17/04141/FUL

**Stratton Place
42 Gloucester Road
Stratton
Cirencester
Gloucestershire
GL7 2LA**

Redevelopment to provide the erection of a 64 bed care home, 8 care suites, 34 assisted living units, ancillary accommodation and associated works (Variation of conditions 2 and 5 of 15/3052/FUL to amend the approved landscaping scheme) at Stratton Place 42 Gloucester Road Stratton Cirencester Gloucestershire GL7 2LA

Full Application 17/04141/FUL	
Applicant:	Aura Care Construct
Agent:	Hunter Page Planning Ltd
Case Officer:	Mike Napper
Ward Member(s):	Councillor Patrick Coleman
Committee Date:	13th June 2018
RECOMMENDATION:	PERMIT

Author	Stratton Place, Cirencester
Client	Clare House Care Group
Drawn	Landscaping Strategy
Scale	1:50/1:200
Date	15/07/12
Drawn by	A
Checked by	
Scale	1:50/1:200
Date	21/08/13
Drawn by	
Checked by

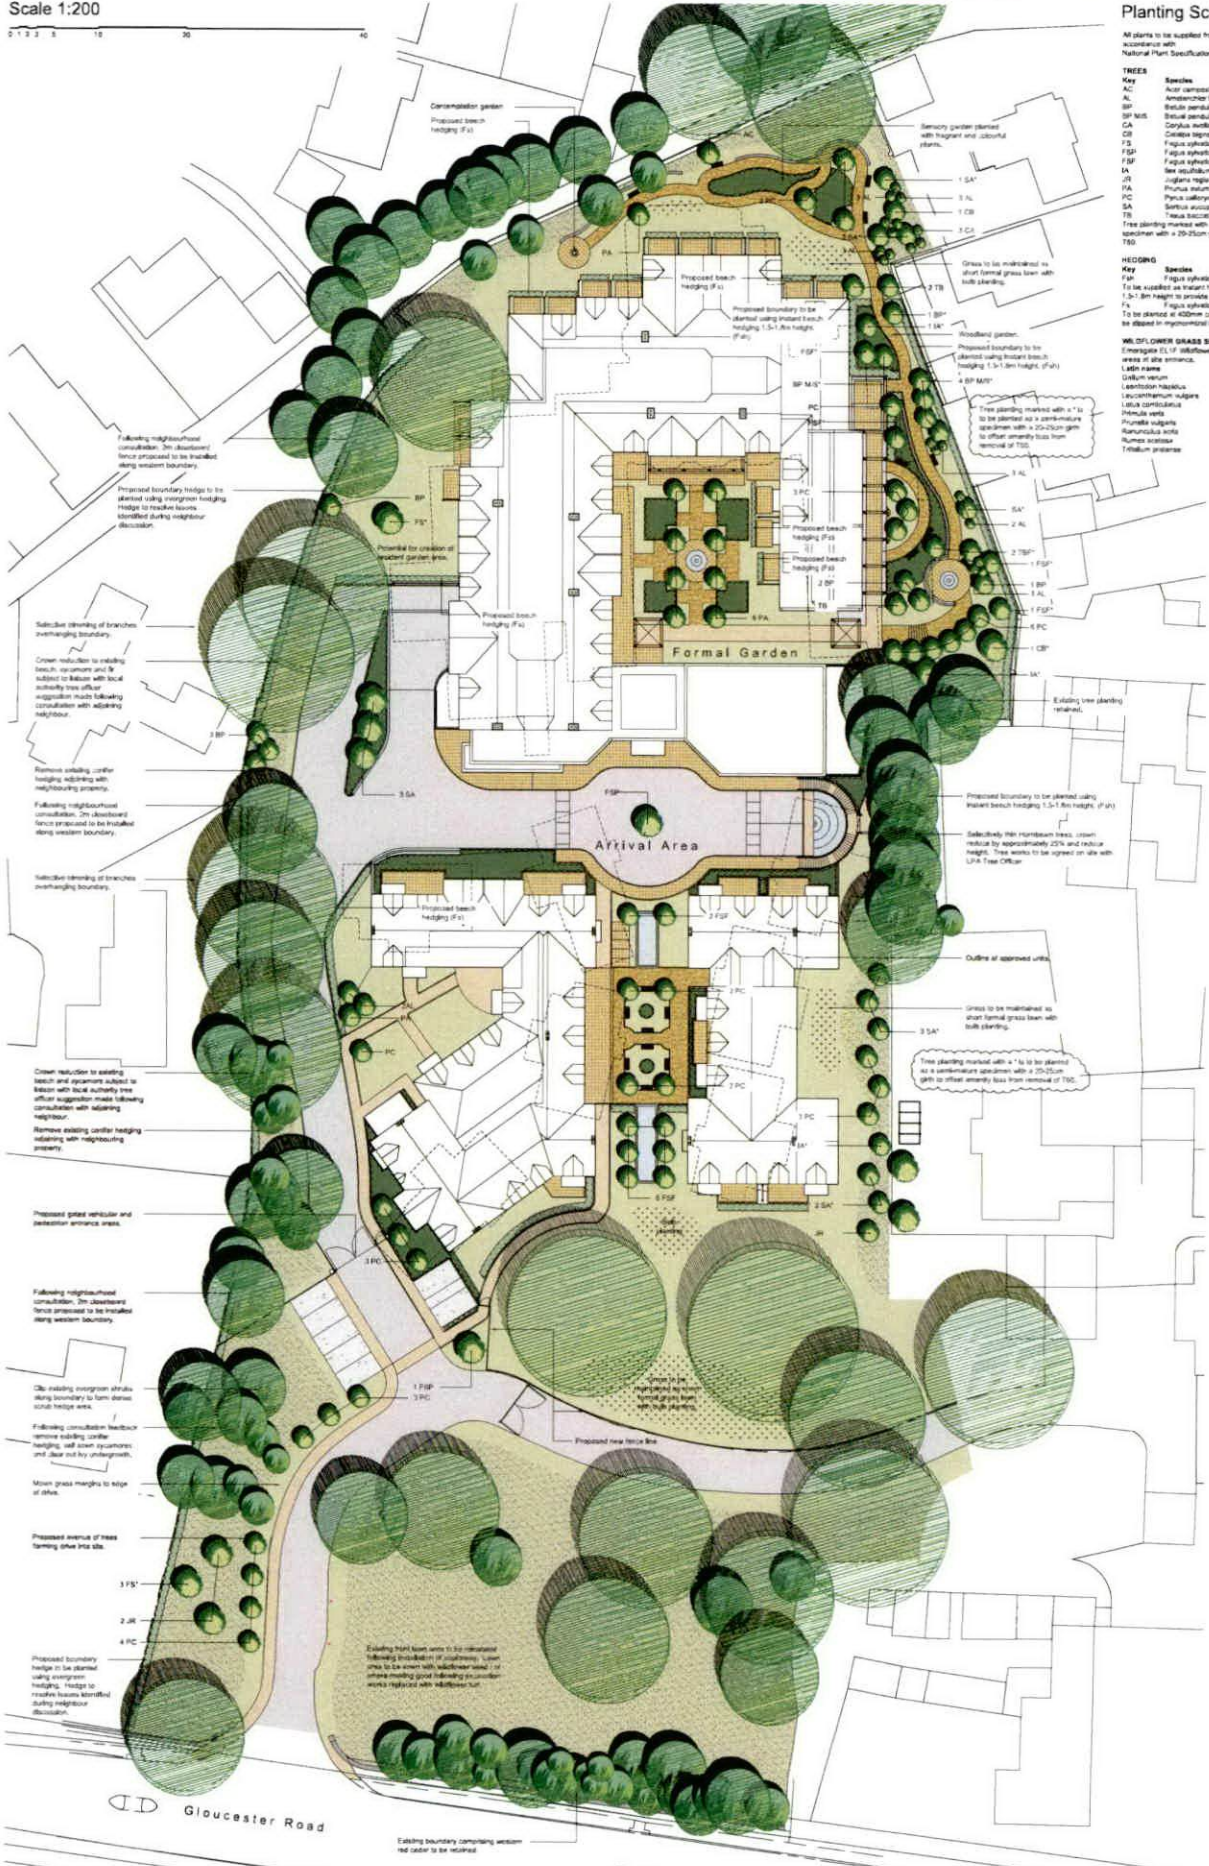
At point A, in the previous plan there were two trees, positioned in a key location to mitigate the impact of the buildings. These have now been replaced by shrubs which completely removes the mitigation effect. These trees should be reinstated. The landscape officer has observed that they

At point B, the view from Albion Street (lane) - which is in the public realm - is totally exposed. A single line of tree planting will not prove sufficient to mitigate the looming and overbearing effect of the development from this viewpoint, and tree planting in some depth should be provided here. That would also help to mitigate the effect of the additional hard landscaping proposed. This is also an area where drainage works are planned, so it is possible that proposed tree planting will be compromised.

At point C, a large concrete manhole has been constructed, and we assume drainage runs coming and going from it. The committee should be entirely satisfied that the proposed trees shown in this area will not be in any way compromised by the drainage. (This is an instance where the landscaping and drainage plans should be examined side by side.) . In any event to ensure adequate planting we would suggest more trees where shown rather than the sitting out area. We believe if the sitting area is provided it will reduce the necessary planting area.

We note that some planting is specified at 3.8-5.0 metres height at the time of planting: we would suggest that this specification be extended to all tree planting in the scheme, in order to provide an immediate degree of mitigation (rather than waiting for trees to grow to maturity over a period of time.

We also note that the degree of screening on the boundary with Stratton Laurels appears to be totally inadequate, and will result in significant intrusion and loss of privacy to these properties. Overall, we are dismayed to note that the overall quantum of tree planting proposed is significantly less than what was included in the original, consented scheme. The additional trees requested as part of this representation are essential as an absolute minimum if this scheme is to be regarded as satisfactory.

Local Residents' Group latest comments: "We have reviewed the amended landscaping plan (revision K) and are pleased to see that the applicant has taken note of the requirement for the additional planting and that these are to be planted into a bed and not containers. It is crucial this is fully implemented.

However we are concerned to note that this is the only apparent change to the plans previously submitted and appear to take no account of comments previously submitted (24 April, 3 January, 20 December 2017, 13 December etc.). We are especially extremely concerned that no change has been made to the inadequate planting at the end of the lane off Albion Street. The planting at this location achieves little or no mitigation against the bulk of the buildings on the development site and the overbearing effect visible from the public realm. Again we urge the Council to require a level of planting screening mitigation that is better than that originally approved, as agreed to be necessary to mitigate the additional impacts of the building. In any event the current proposals amount to a significant reduction compared to the originally approved plan in the planting that was to be provided to mitigate this view and the proposals remain unacceptable in this regard. Also as previously noted the extensive hard surfacing particularly in this location is also at odds with the approved proposals. We have previously suggested that these shortcomings could at least be improved by creating a bed of the currently paved arc in this zone and planting 3 additional significant trees. Otherwise the planting mitigation here is solely relying on a single line of trees which is wholly insufficient.

We note the proposals still indicate the removal of one of the 2 large conifers. However the implemented scheme on site currently retains both and appears to do so quite happily. Both trees should be retained.

A copy of the final landscaping scheme is attached to this report, which shows its full details, together with a copy of the currently permitted landscaping scheme from 2017. In summary, however, the revised proposals show a 2 metre high close-boarded fence along the full length of

the north-west boundary together with tree and hedge planting behind it. Where previous vegetation has been unmanaged, the planting proposals include more appropriate and effective species (e.g. previous cypress hedge to be replaced with laurel). In some instances and in agreement with the Council's Tree Officer, trees in poor condition or of an inappropriate species have been removed. The north-eastern (Albion St) boundary would comprise a 2 metre louvered fence mounted on a 450mm high retaining wall with new hedge planting behind it. The circular mobility buggy path would lie behind this hedge and new tree planting of two rows in depth, with some of more mature stages of growth (e.g. 3m high birches and 1.75m high hazel) together with shrub planting below, would be provided between the path and the building itself. There would be glimpsed public views from Albion Street of the latter planting and further tree and hedge along the south-eastern boundary and officers consider that these views and the associated impact on neighbours along this boundary would be improved relative to the more sporadic planting previously approved. Whilst it is inevitable that the facade of the building will always be a dominant, and arguably overbearing, feature particularly along the north- and south-eastern boundaries, the proposed planting would have the effect of visually softening and filtering those views, and increasingly so over time. Officers consider that the additional planting suggested by the Local Residents' Group in this location would add little material benefit, and that the current proposals show a greater density of planting than previously approved.
